Subject: **Comment Letter – Foothill Mini Mart Case Closure Summary**, Notice of Opportunity for Public Comment; Underground Storage Tank Cleanup Fund Case Closure Recommendation; Claim Number 14095; Fuel Leak Case No. RO0000175 and GeoTracker Global ID T0600102286, Foothill Mini Mart 6600 Foothill Boulevard, Oakland, CA 94605

**Summary of ACEH’s Review of the USTCF’s UST Case Closure Summary**

Figure 2

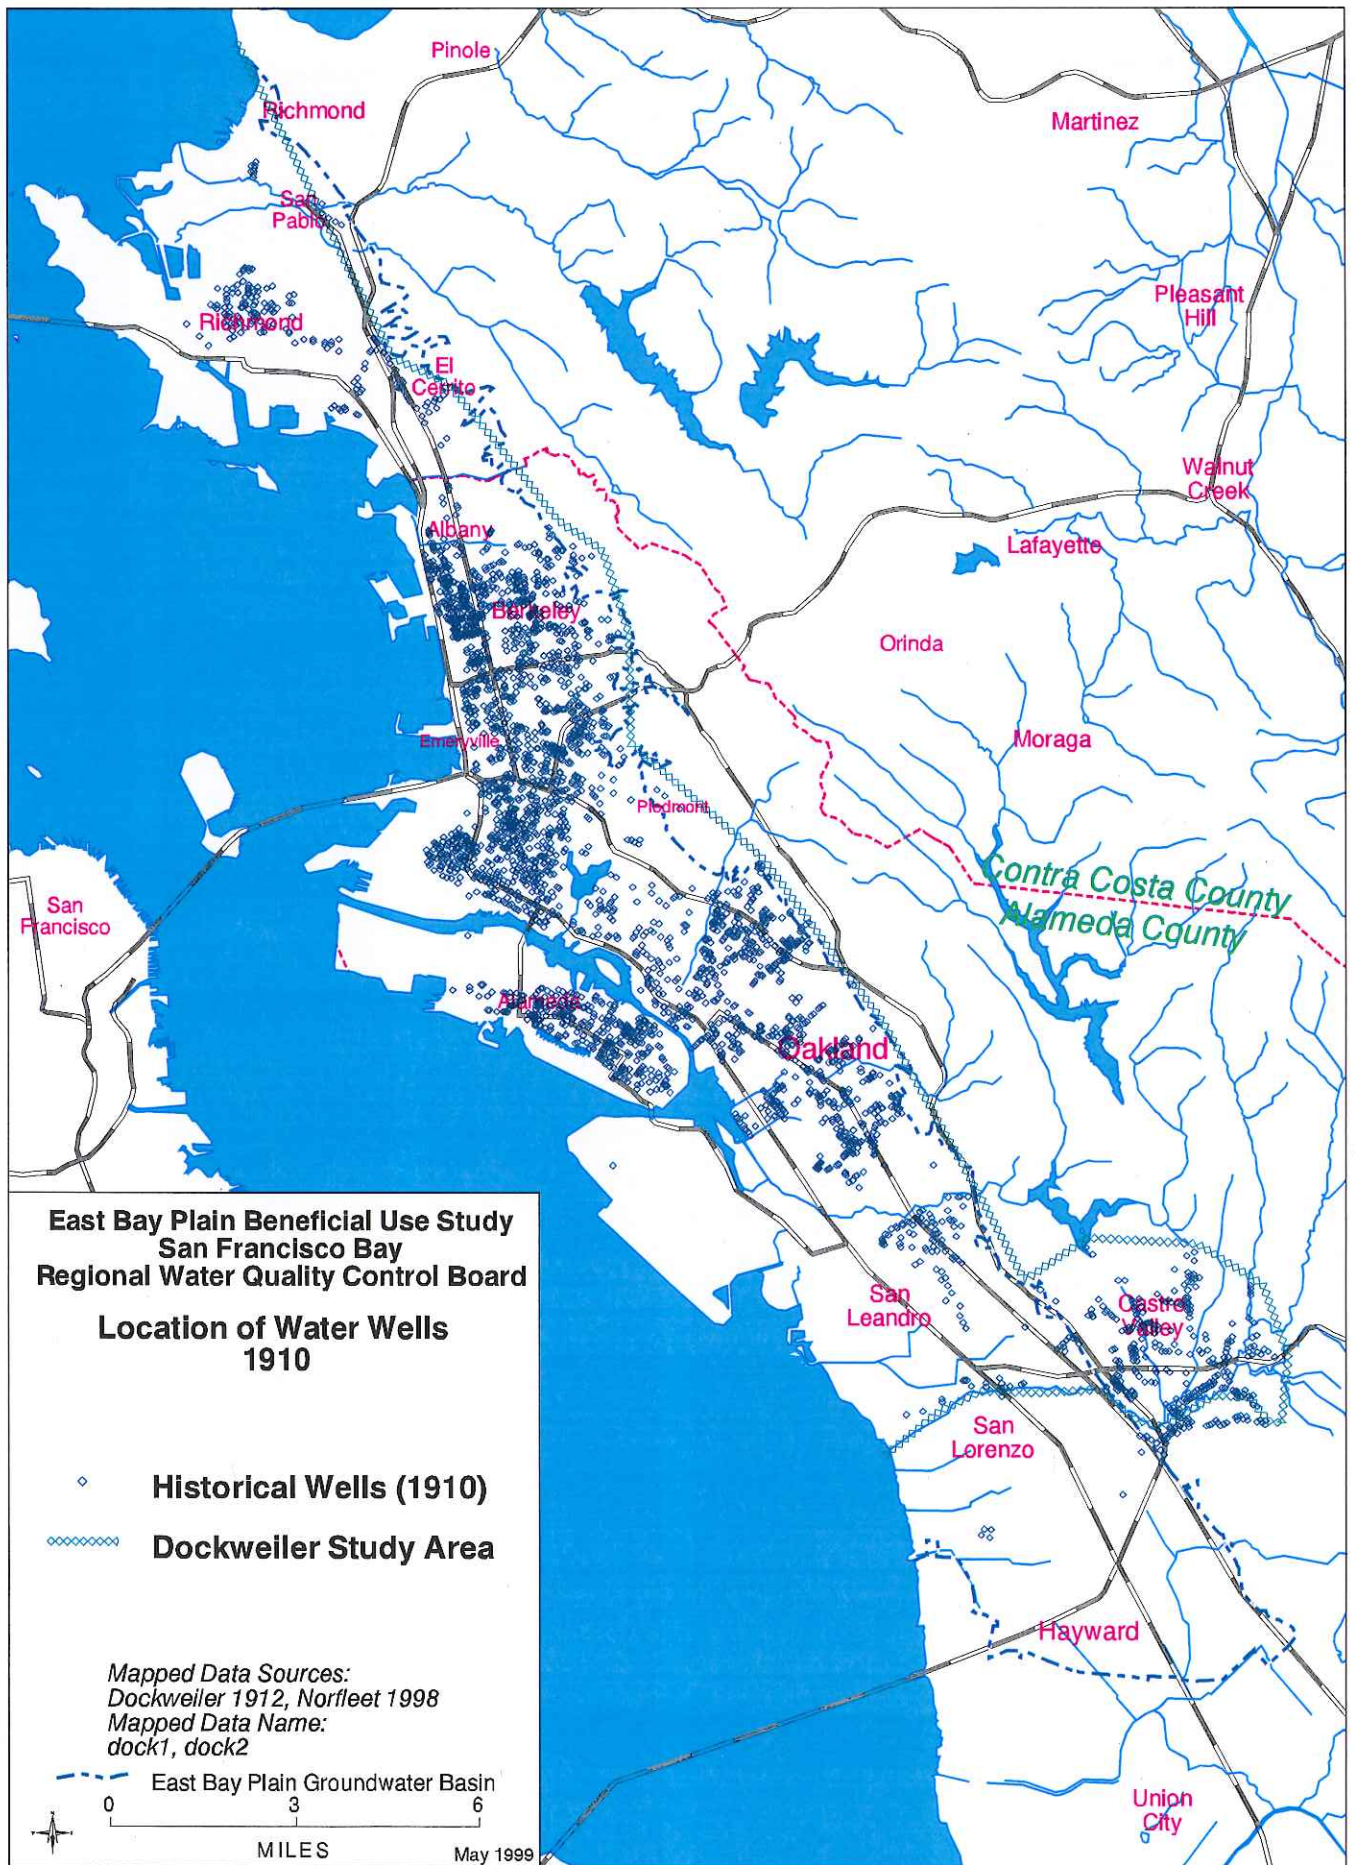
The site is located in an older community consisting of mixed use commercial and residential properties and is in an area identified to contain domestic and commercial water supply wells. Attachment 1 presents documents that demonstrate well locations in 1910. A table comparison of current East Bay Municipal Utilities District (EBMUD) and Alameda County Flood Control and Water Conservation District (ACFCWCD) databases of existing wells indicates the EBMUD database contains more comprehensive well location data. However the EBMUD database was not reviewed for the sensitive receptor survey. The EBMUD database consists of addresses where backflow prevention devices have been installed for residential and commercial properties which have volunteered that they have wells. The ACFCWCD database contains records of permitted wells drilled after July 17, 1973 and wells documented by the California Department of Water Resources (DWR) for groundwater investigation in Alameda county in the 1960s. The EBMUD backflow prevention device database contains many more well locations (400 versus 32) for the City of Oakland. The position of ACEH is potential well presence in the site vicinity presents a unique site attribute or site-specific conditions that demonstrably increase the risk associated with residual petroleum constituents.
